County of Fairfax, Virginia

Re: Interpretation for RZ 2004-SU-028 and SE 2004-SU-027; Tax Map 33-4 ((1)) 3G;
14840 Stonecroft Center Court; Penske Automotive Group: Sign

Please accept this letter as a request for determination of substantial conformance to a previously approved sign exhibit for the referenced SE & SEA.

CLIENT:	Chantilly Audi
LOCATION:	Chantilly, VA
DATE:	03-18-10
DRAWING #:	AUD-Chan-PT.1
DRAWN BY:	PN

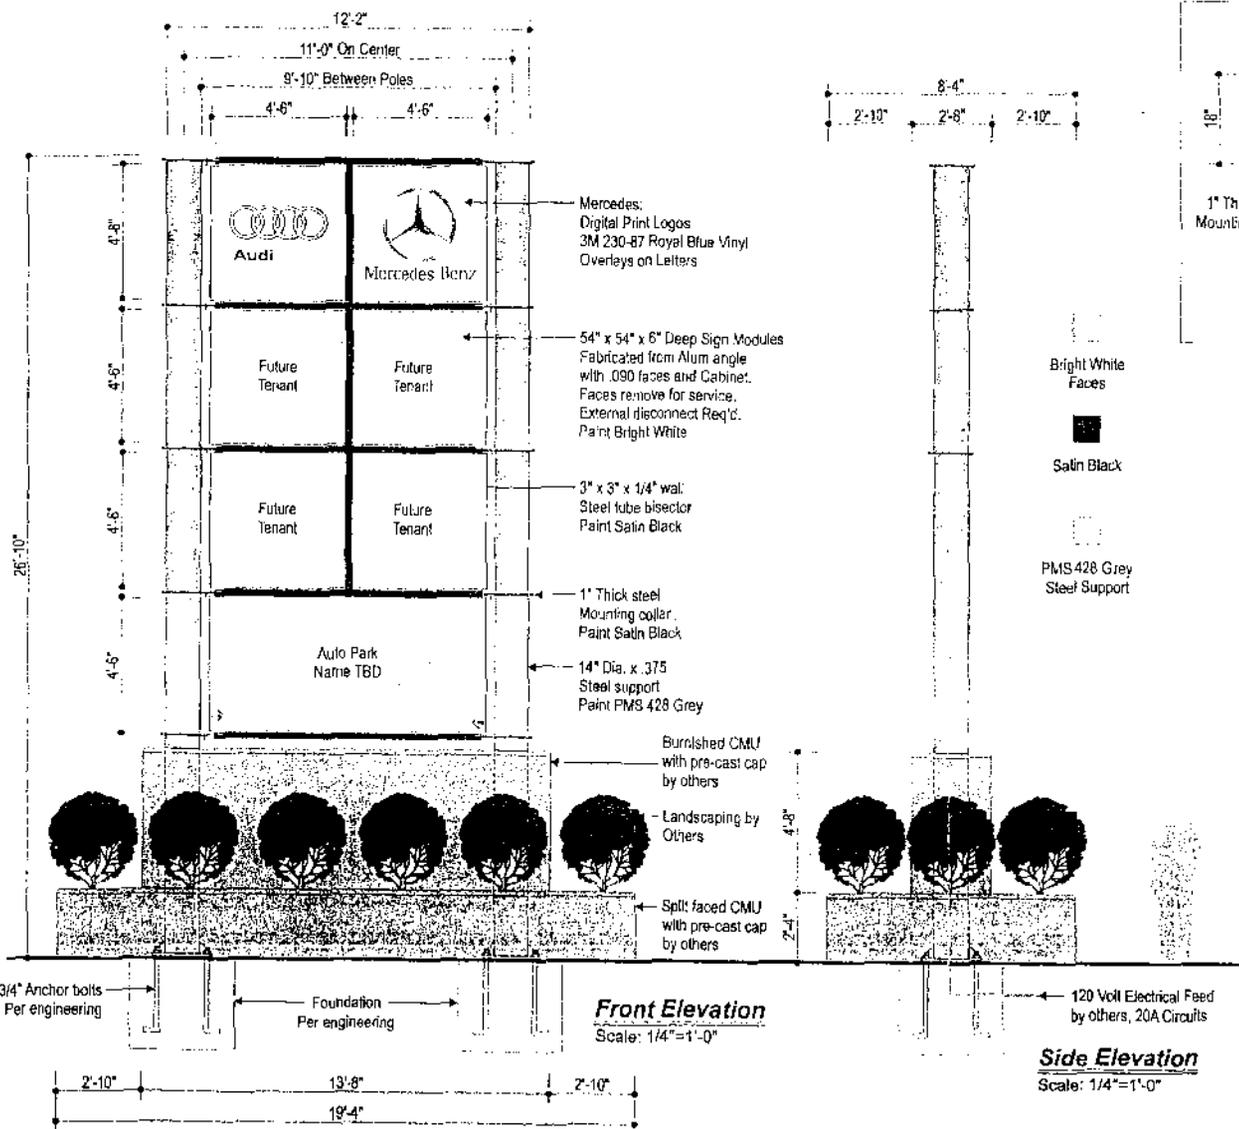
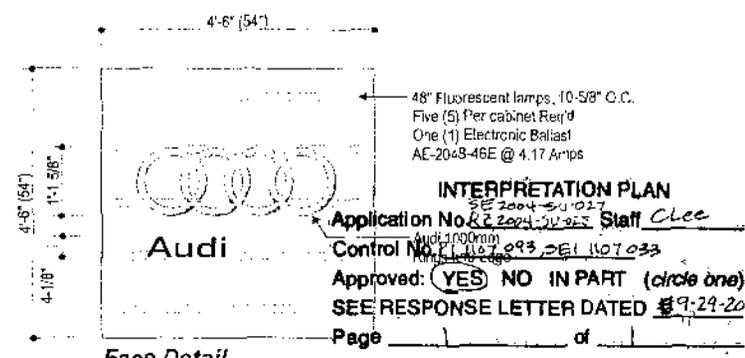
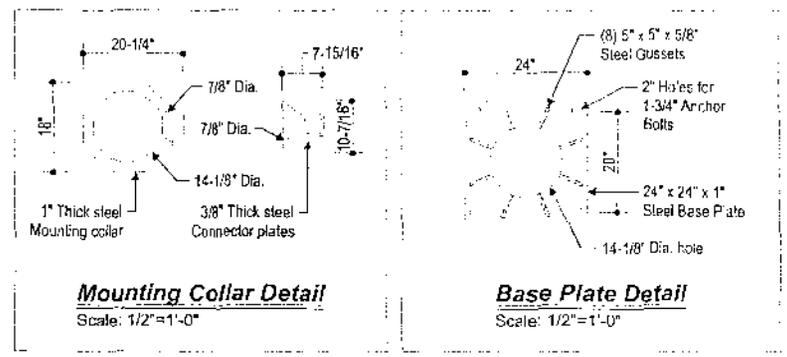
According to your letter, you propose to modify the size of the sign from that previously approved. You state the sign structure has been modified by the manufacturer's design to install 14" wide support columns, rather than 10" depicted with the previous interpretation exhibit. The increased width of the support columns results in an overall sign width that is 6" wider than that approved with the previous interpretation, from 11'8" wide to 12'2" wide, and is 2'8" wider than that approved with the SE for 9'6" wide. According to the sign permit submitted to Zoning Inspections Branch, the sign area is unchanged from that proposed with the previous interpretation (231 square feet).

In addition, you propose to change the sign wording, shown with the previous interpretation, due to possible legal issues with the use of the trade name "Chantilly Auto Park II". You state that the lower panel will state the auto park trade name, once it is determined, subject to the provisions of Article 12 of the Zoning Ordinance.

The sign that was previously interpreted as part of the referenced SE & SEA (see attached) labeled as Exhibit (1) prepared by Black Corley Owens & Hughes Architects will require a minor modification to the design caused by changes in the structural support columns by the manufacturers' engineer. The original rendering called out 10" support columns for the sign structure and the engineer for the sign manufacturer has replaced these columns with 14" support columns. This structural change has caused the overall width of the sign to increase from 11'-8" to 12'-2" a difference of 6".

The other change from the original exhibit is the omission of the name "Chantilly Auto Park II" on the bottom sign panel. Penske Automotive Group has discovered some possible legal issues with the use of the trade name "Chantilly Auto Park II" and will use the lower panel for the trade name of the auto park once this has been determined.

It is my determination that the proposed increase in sign width to 12'2" and the change in the auto park trade name, once it is determined, would be in substantial conformance with the proffers, GDP/SE Plat and development conditions, provided that the sign complies with all other provisions of Article 12 of the Zoning Ordinance, subject to the approval of the Zoning Inspections Branch, Zoning Administration Division. This determination has been made in my capacity as the duly authorized agent of the Zoning Administrator and only addresses the issues discussed herein. If you have any questions regarding this interpretation, please contact Carrie Lee at (703) 324-1290.
